REQUEST FOR INFORMATION **DATE:** November 15, 2016 **NO.:** RFI-347

Project Name: 15051-Webster University Interdisciplinary Science Building Project No.: 15051

Subject: Outlet for Drain tile in tunnel between EAB and ISB

P0101.B

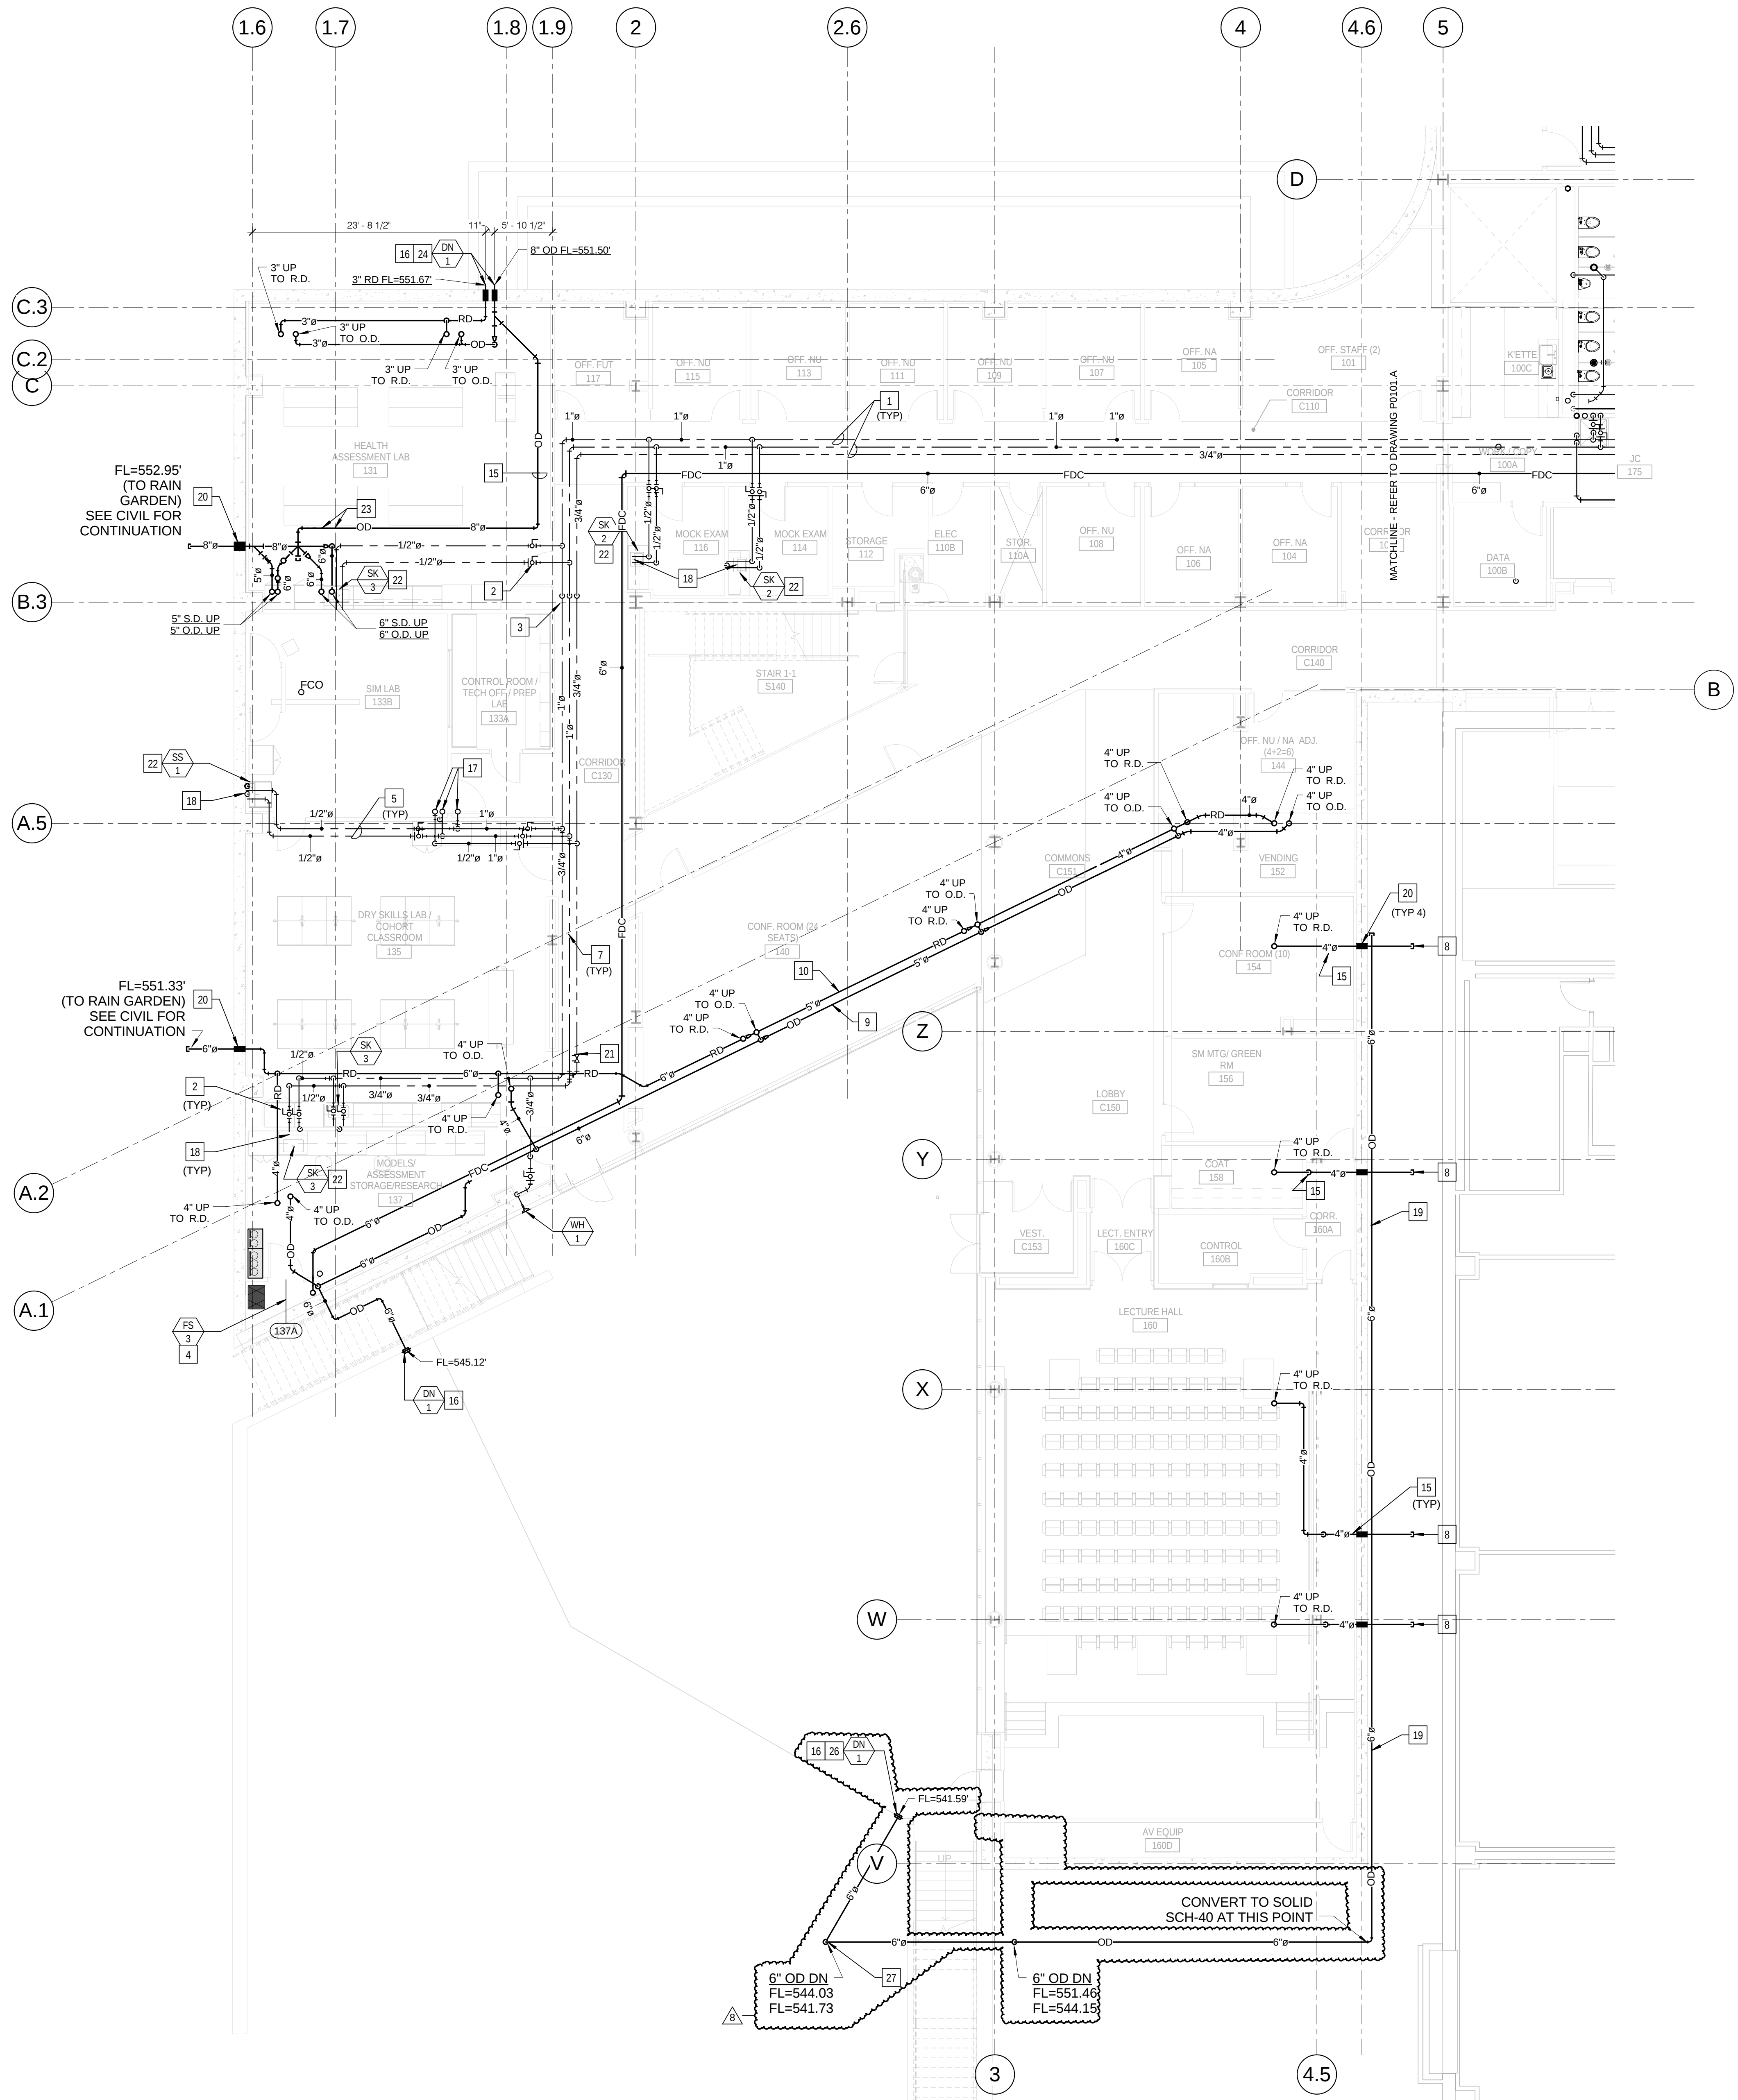
Reference P0101.B. Please advise of alternate routing for the drain tile exiting the building near column line V3. We understand the preference to be for the drain tile to remain at the exterior of the building and for it to go underneath the stairs and exit in the grass area above the courtyard seat wall. Please provide elevations for this line to penetrate the concrete foundations at the stairs and elevation for termination point.

The overflow drain piping is not to be run into the building as shown. If the sleeves have been set, they are to be grouted, soiled and waterproofed as directed by the Architect.

The 6 inch overflow drain pipe is to be routed under the stairs, turned down to a double 90 elbow and extended to discharge through the concrete seat wall. Downspout nozzle (DN-1) is to be relocated to this location.

Refer to the attached drawing P0101.B (delta 8, dated 16 Nov. 2016)

- 26 COORDINATE LOCATION AND INSTALLATION OF OVERFLOW DRAIN PIPING WITH TRENCH DRAIN AT UPPER LEVEL OF SEAT WALL.
- 27 INSTALL DOUBLE 90 DEGREE ELBOW FITTINGS TO ALLOW OVERFLOW PIPING TO BE PERPENDICULAR TO CONCRETE SEAT WALL.
